Subject: 38 The Drive New DA 2022/1128 - Our Ref: key.sed1f

DEMOLITION OF EXISTING DWELLING HOUSE AND CONSTRUCTION OF A NEW PRINCIPAL DWELLING AND A DETACHED SECONDARY DWELLING OVER A GARAGE, TOGETHER WITH A SWIMMING POOL & LANDSCAPING AT 38 THE DRIVE FRESHWATER (DA 2022/1128)

This document is a submission by way of objection to Development Application DA 2022/1128 (the 'development application') relating to No 38 The Drive, Freshwater (the 'subject property' or 'site').

Figure 3 – Extract from drawings by Northern Beaches Designs showing southern elevation of proposed principal dwelling (NTS)

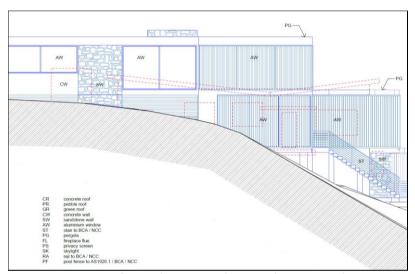
We say significant impacts to views to the north east will be caused by the proposed development. The greatest effect is as respects the dining/kitchen area from which there will be caused a severe view loss. Clearly no cross views are retained. The drawing below (Figure 3) illustrates the bulk and scale of proposal and relationship with northern boundary of our clients property.

Figure 4 – Showing north elevation (Northern Beaches Designs Sheet DA 13)

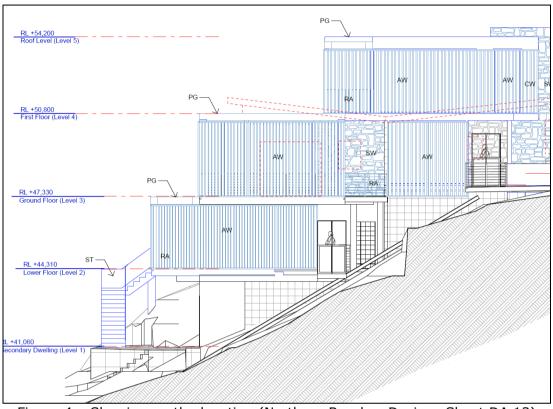
The above extract from the plan set demonstrates the non-compliance with the HOB control. Note that if the drawing is correct, it appears to show the building extending from approximately RL44.5 to RL54.2 at its highest point which is a height of some 9.7m. The more eastward height where the development steps down a storey is similar based on the proposed RL's. Note height of existing dwelling house shown red dotted with the roof of same a full storey below the proposed height of the new structure. The existing structure still dominates on the top of the bluff, so one should imagine a built from with twice that height.

We call for Council to reject the application in its current form and require the applicant to provide an amended scheme, which addresses the significant issues associated with the current design.
